**LIMA WATER SYSTEM IMPROVEMENTS
CONTRACT 1: UPGROUND RESERVOIR
2009
ADDENDUM NO. 2**

The following addendum items modify, change, delete from or add to the requirements of the May 2009 Contract Documents for this project. The articles contained in this Addendum No. 2 take precedence over the requirements of the previously published Contract Documents. Where any article of the Project Manuals or any detail of the Contract Drawings is modified or any Article, Paragraph, Subparagraph or Clause thereof is modified, added or deleted by the articles contained in this Addendum, the unaltered provisions of that Article, Paragraph, Subparagraph or Clause shall remain in effect.

TYPICAL ACCESS RAMP DETAIL

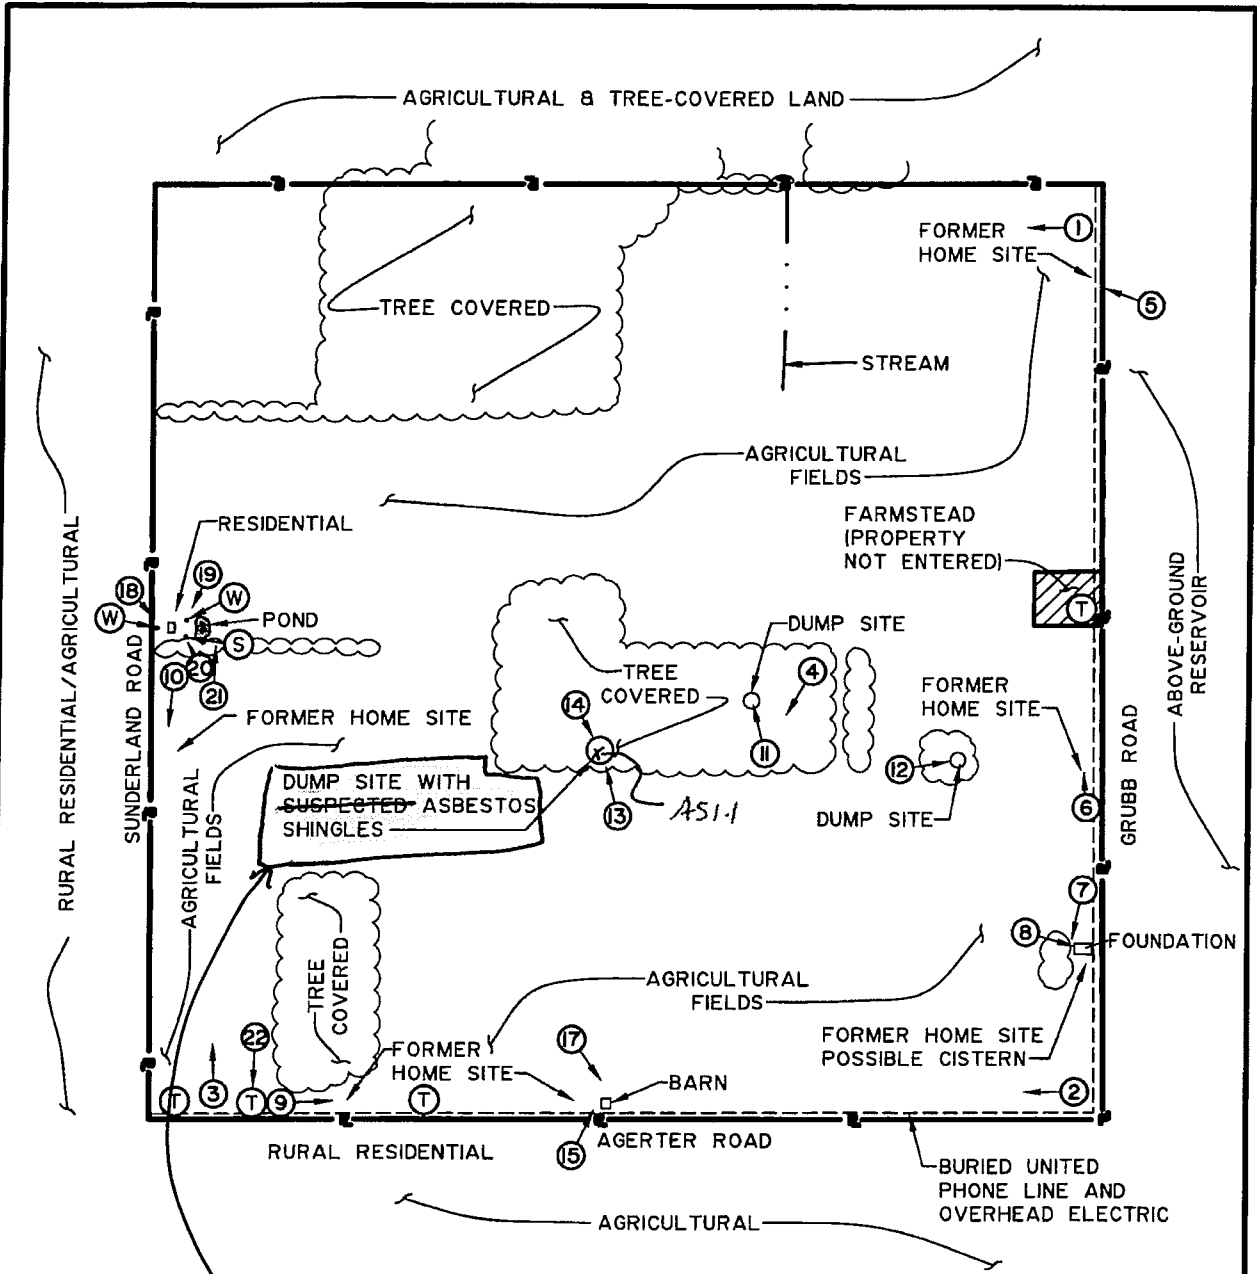
1. Revise Plan Sheet M-1, Material Specifications. Structural Fill to meet the requirements of Section 02300. Revise the percent of material passing the No. 200 sieve to be 50 percent.
2. Revise Plan Sheet C-14 . Replace the Typical Access Ramp Detail with the attached detail.
3. Revise Plan Sheet C-5 to add a second debris pile as shown on the attached sketch. Results of asbestos testing information on cement siding from this additional debris pile is attached.
4. Revise Plan Sheet C-4.3 as follows. The piping between CB-43 and CB-44 and between CB-44 and CB-45 is 30 inches in diameter. Revise CB-44 to be an ODOT CB 2-3.

PLACE TURF REINFORCEMENT MAT
 APPROXIMATELY 6.5' WIDE
 (ONE ROLL WIDTH)
